# Whistling Ridge Energy Project

## Final Environmental Impact Statement

### Appendix G

## **APPENDIX G – RESPONSE TO COMMENTS**

**Figure G1.** Project Siting for the Whistling Ridge Energy Project using Tract Suitability Analysis.

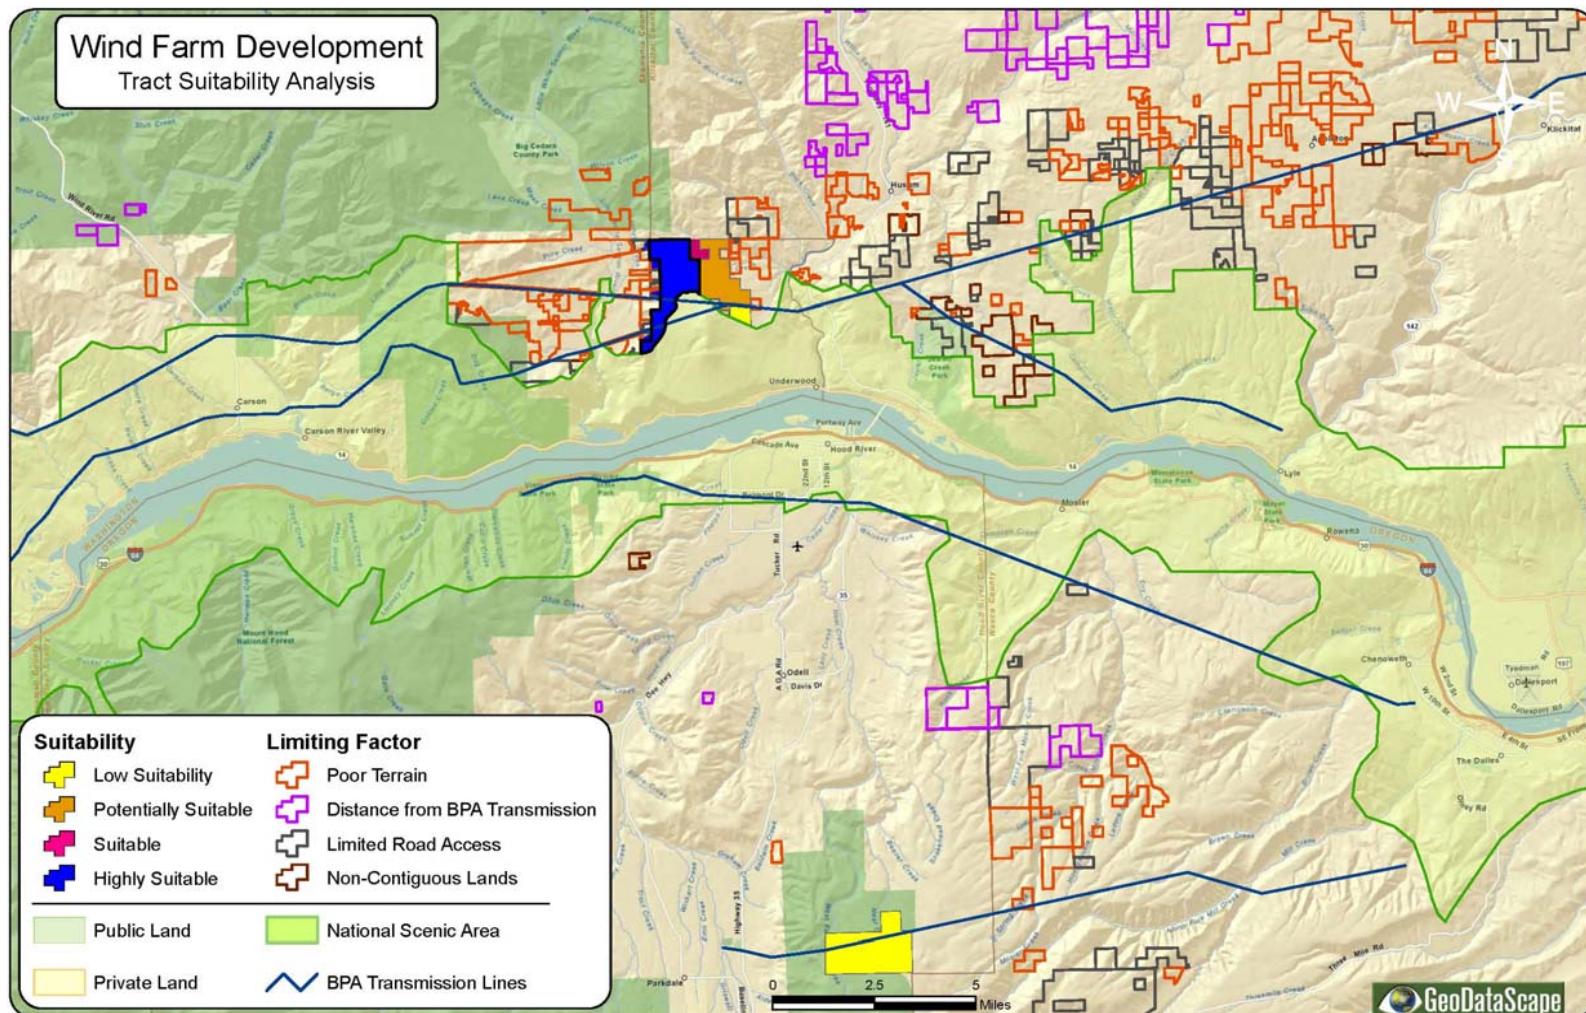
- Low suitability properties: These are parcels that are within 3 miles of transmission lines, are outside the NSA boundary, have a terrain difference of between 200 and 500 feet, and have road access. These parcels are designated in yellow on the “Tract Suitability Analysis” map (see Figure G-1).

- Potentially suitable properties: These are parcels that are within 3 miles of transmission lines, are outside the NSA boundary, have a terrain difference of between 500 and 1,000 feet, and have road access. It should be noted that these parcels could be ruled out as being unsuitable based on other factors not assessed in this analysis, such as slope direction or parcel size. These parcels are designated in brown on the “Tract Suitability Analysis” map (see Figure G-1).

- Suitable properties: These are parcels that are within 3 miles of transmission lines, are outside the NSA boundary, have a terrain difference of between 500 and 1,000 feet, and has what appear to be better road access than properties identified as “potentially suitable”. These parcels are designated in dark pink on the “Tract Suitability Analysis” map (see Figure G-1).

- Highly suitable properties: These are parcels that are within 3 miles of transmission lines, are outside the NSA boundary, have terrain differences between 1000 and 2000 feet above surrounding terrain and contain the highest hills/ridgelines within the study area, and have good road access. These are the best possible locations within the study area for wind facility development. Of the analyzed parcels, only 1 parcel fell into this category. These parcels are designated in blue on the “Tract Suitability Analysis” map (see Figure G-1).
